MEMORANDUM

TO: District of Columbia Zoning Commission

SUBJECT: ZC #12-01B – Catholic University – Campus Plan Amendment and Further Processing for a Dining Hall

Excerpt From Approved 2012 Campus Plan (Exhibit 17 of the Campus Plan, p. 67)

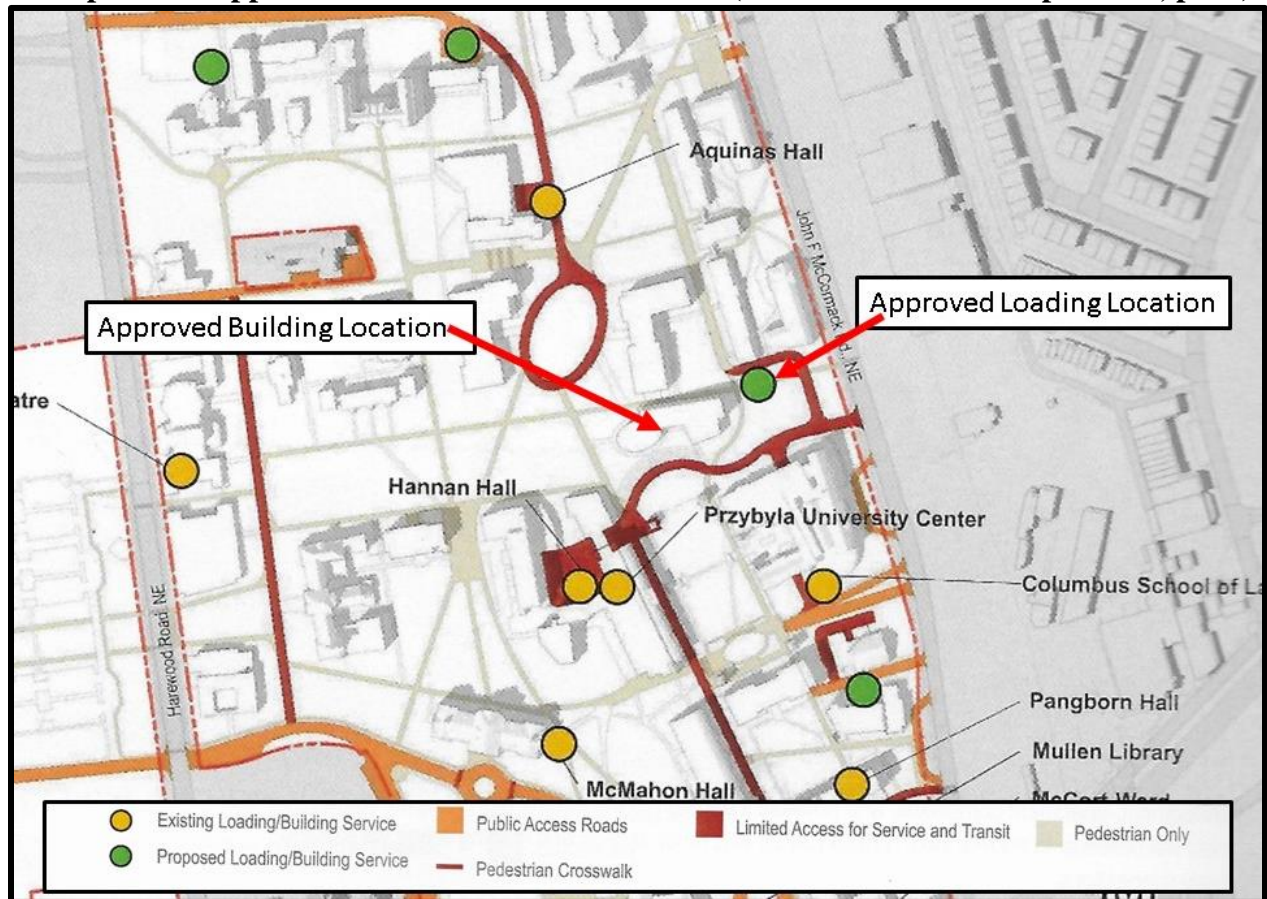
The proposed campus plan amendment would move the proposed building south, off the central east-west axis, and would not present a building face orthogonal to the future quad. The revised campus plan suggests a tower focal point for the walkway on the south side of the proposed quad.

The proposed building in the campus plan amendment would appear to be approximately the same size as the formerly proposed building, just altered in shape and location. The amendment would also appear to remove a formerly proposed building shown as “C1” on the approved plan, which would have been located north of the Pryzbyla Center. The overall result in the ultimate condition would be a less formal arrangement of buildings around the east-west quad, and no central visual terminus. Pedestrian circulation in the proposed campus plan would be enhanced by allowing pedestrian movement through the center of the building, providing a direct connection from the law school quad to uphill uses. Please refer to the excerpt from Exhibit 16A below, the applicant’s proposed campus plan.

Excerpt From Approved Vehicular Circulation Plan (Exhibit 26 of the Campus Plan, p. 93)

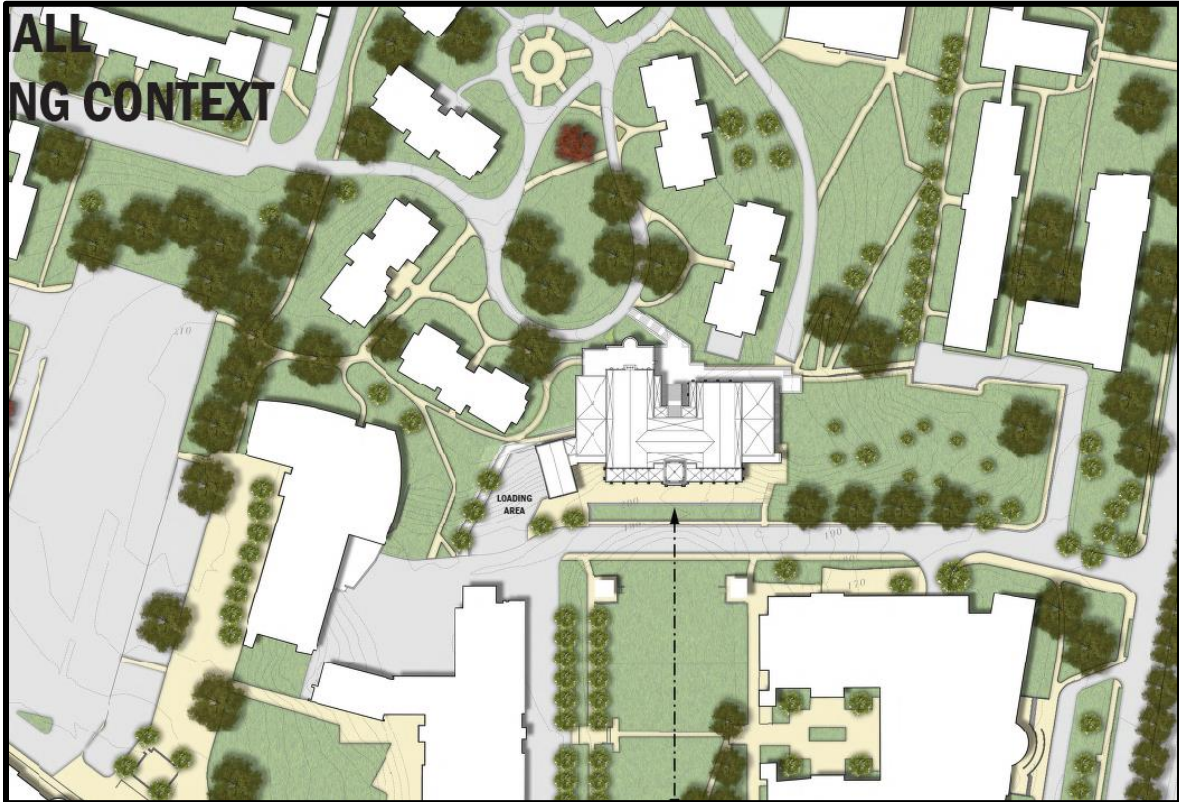
The approved campus plan provided for continuation of the loading area at the Przybyla Center, but contemplated that future loading would occur at the periphery of the campus. Specifically in this case the building in question would have had loading on its eastern end. The campus plan amendment proposes to allow an expansion of the existing loading facility to serve the new dining facility, and, with a reduced east-west footprint for the proposed building, eliminate the loading area on the east side of the building. Please refer to the approved circulation plan below, as well as the proposed site plan.

As seen on the site plan above, the interim condition would retain the other dorms of Centennial Village. The campus plan amendment does not propose any changes to enrollment or staffing numbers, or any of the conditions approved with the 2012 campus plan. According to the applicant's statements in Exhibit 12, the University currently complies with all applicable conditions.
